Appendix G

Clarifications and Edits Resulting from the “Test Drive Period”

Background. This Appendix includes clarifications and edits resulting from the 6-month Test Drive. Because of the complexity of the stream restoration protocols, the Expert Panel decided there would be a “Test Drive Period” so that states and localities could “test” the protocols on actual projects. The results would identify sections of the reports that require clarification or editing to improve the protocols.

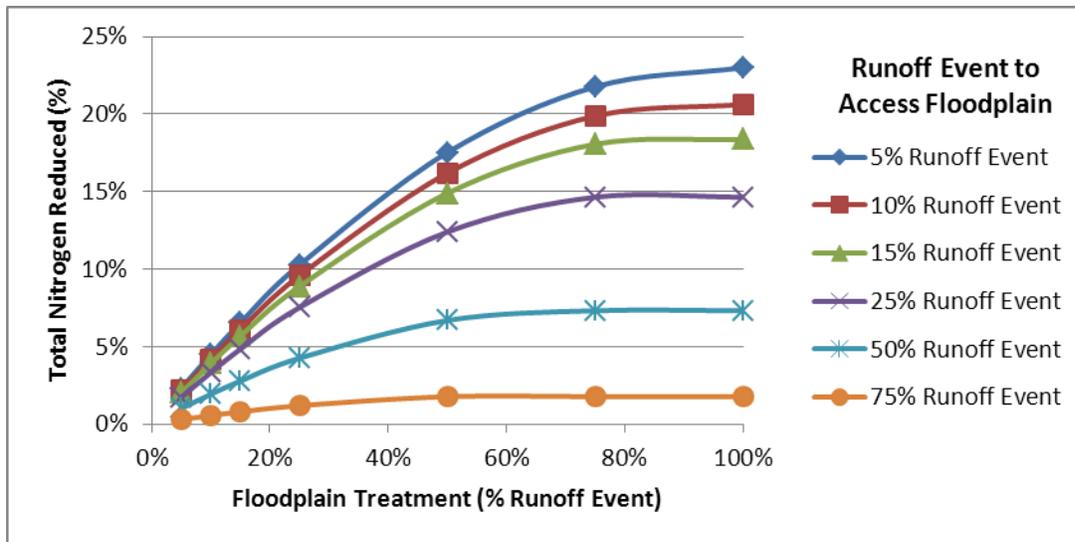
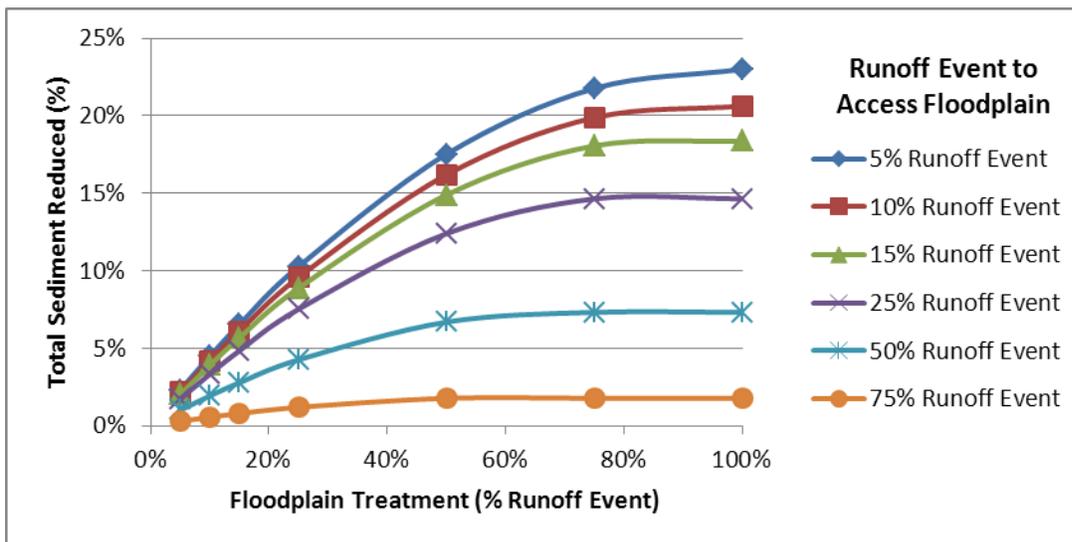
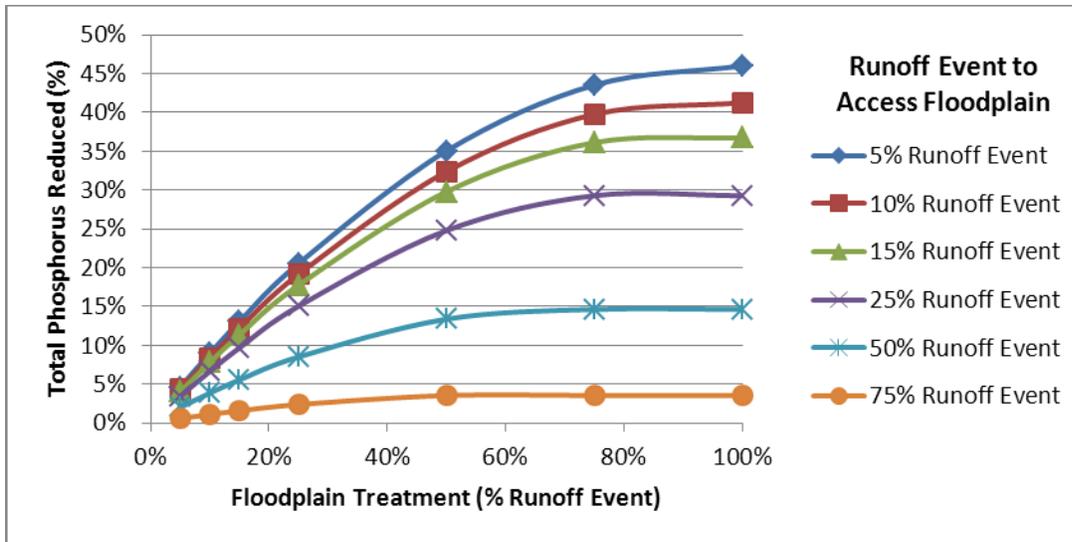
Q-10: Can the Protocol 3 curves be adapted to different hydrological methods that are typically used in stream restoration design?

This became evident in the test drive period of the stream restoration protocols which suggest that using rainfall data as a surrogate for runoff on the Protocol 3 curves significantly overestimates the annual runoff volume, thus underestimating treatment. While the fraction of total annual precipitation may be significant for smaller rainfall events, the fraction of total annual discharge resulting from those smaller rainfall events may be much lower, due to abstraction and interception which occurs in small events.

A-10: The curves developed for Protocol 3 were based on the frequency distributions of rainfall from records from National Airport. To develop the curves, an assumption was made that runoff volume followed the same frequency distribution as rainfall. This assumption works for small LID type designs however does not hold for projects such as stream restoration that require more complicated hydrologic methods. Therefore the curves developed in the Expert Panel report are conceptual in nature and should only be used for planning purposes and not for design. However, the rationale and basis for developing the curves still should form the basis for estimating sediment and nutrient removal for projects that qualify for Protocol 3. The curves will have to be adjusted depending on the hydrologic method used.

Technical Addendum A provides an example of how the curves can be adapted using the Soil Conservation service (SCS) Runoff Curve Number method. This method was chosen because it is one of the more popular hydrologic methods used in stream restoration design.

Based on these findings, the Protocol 3 curves were revised as follows so that they are based on the percentage of runoff as opposed to rainfall depths.

Applying reduction efficiencies, resulting reduction trends for Total Nitrogen (25%), Total Phosphorus (50%), and Total Sediment (25%) are shown in the following figures:

Note: For the above 3 graphs, the 5% runoff event curve means that 95% of all runoff events will access the floodplain.
